SUBJECT: JOSEPH M. FARLEY NUCLEAR PLANT, UNITS 1 AND 2 — ISSUANCE OF
AMENDMENTS RE: STEAM GENERATOR REPLACEMENTS
(TAC NOS. MA4393 and MA4394)

ATTACHMENT TO LICENSE AMENDMENT No. 138

TO FACILITY OPERATING LICENSE NO. NPF-8

SUBJECT: JOSEPH M. FARLEY NUCLEAR PLANT, UNITS 1 AND 2 — ISSUANCE OF
AMENDMENTS RE: CONVERSION TO IMPROVED STANDARD TECHNICAL
SPECIFICATIONS (TAC NOS. MA1364 and MA1365)

Figure 3.4.16-1

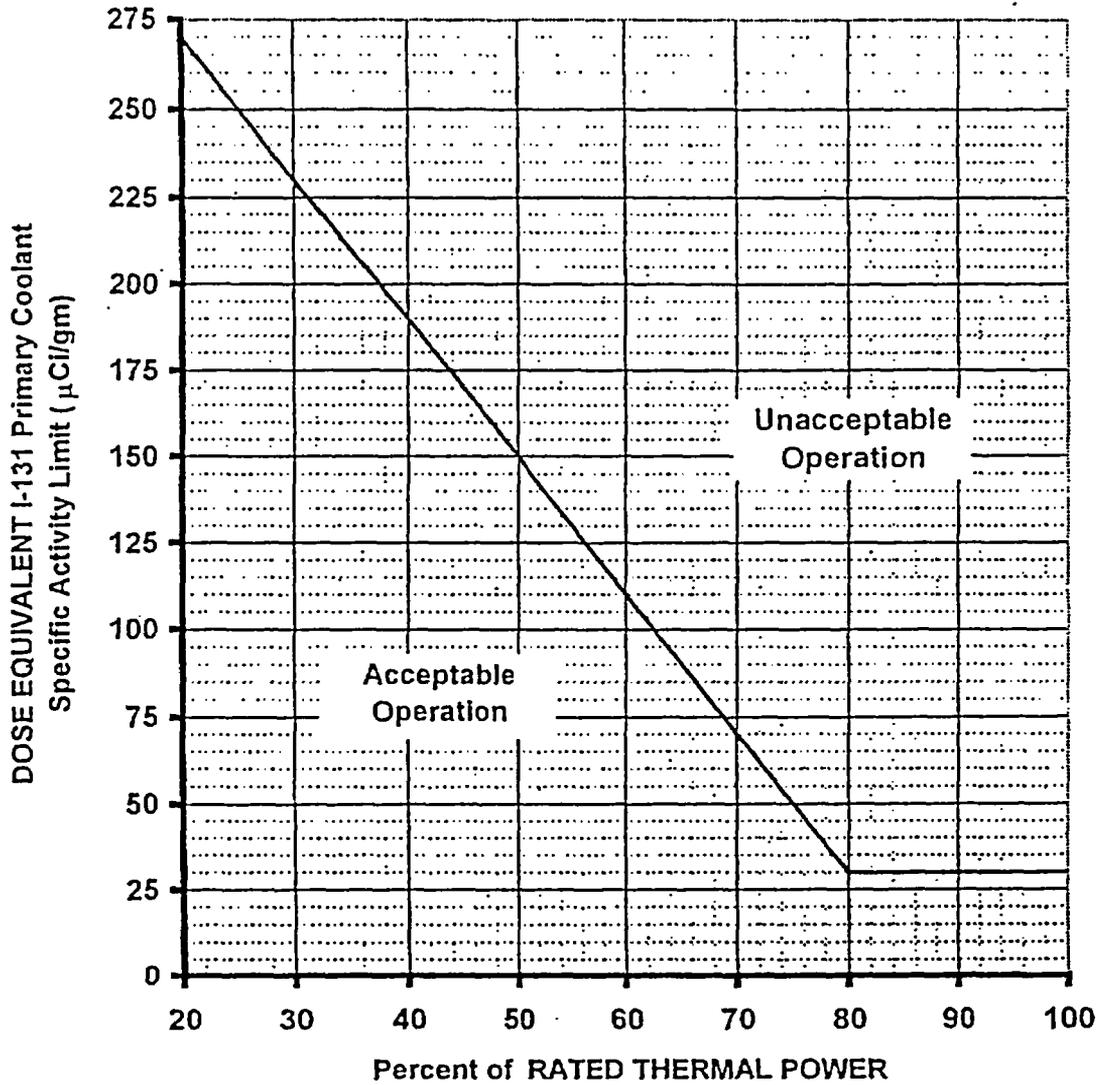
CONDITION	REQUIRED ACTION	COMPLETION TIME
A. DOSE EQUIVALENT I-131 $>$ 0.5 μ Ci/gm.	-----Note----- LCO 3.0.4 is not applicable. -----	
	A.1 Verify DOSE EQUIVALENT I-131 within the acceptable region of Figure 3.4.16-1. <u>AND</u> A.2 Restore DOSE EQUIVALENT I-131 to within limit.	Once per 4 hours 48 hours
B. Gross specific activity of the reactor coolant not within limit.	B.1 Be in MODE 3 with $T_{avg} <$ 500°F.	6 hours

CONDITION	REQUIRED ACTION	COMPLETION TIME
<p>C. Required Action and associated Completion Time of Condition A not met.</p> <p><u>OR</u></p> <p>DOSE EQUIVALENT I-131 in the unacceptable region of Figure 3.4.16-1.</p>	<p>C.1 Be in MODE 3 with $T_{avg} < 500^{\circ}F$.</p>	<p>6 hours</p>
